ENGINEERING CHANGE NOTICE

ECN#1145

FIREFLY IV MANUAL REVISIONS

FIREFLY IV
RELEASE DEVICE
MODEL AR-D

SCHEMATIC

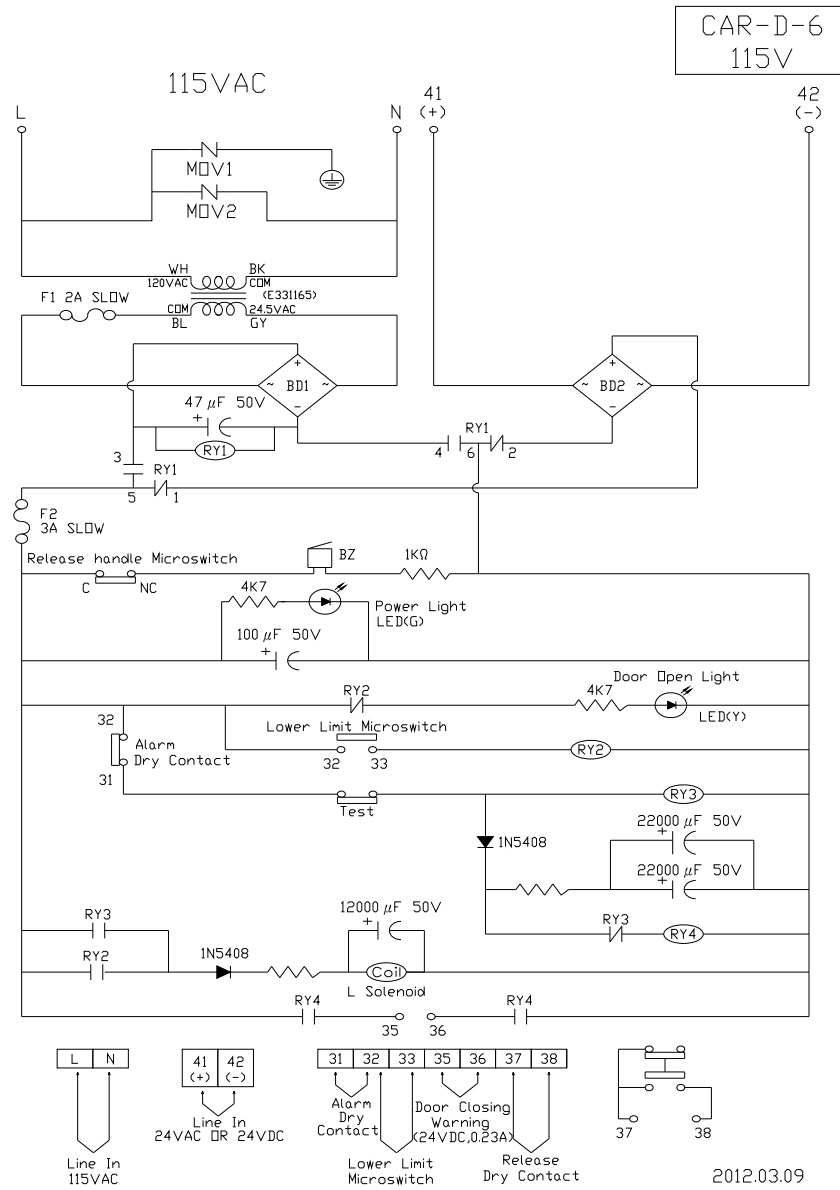
- This ECN revises the Owner's Manual for the Firefly IV Release Device.
 - Vendor made changes to Unit
 - Transformer was changed
 - Fuse Holder was relocated
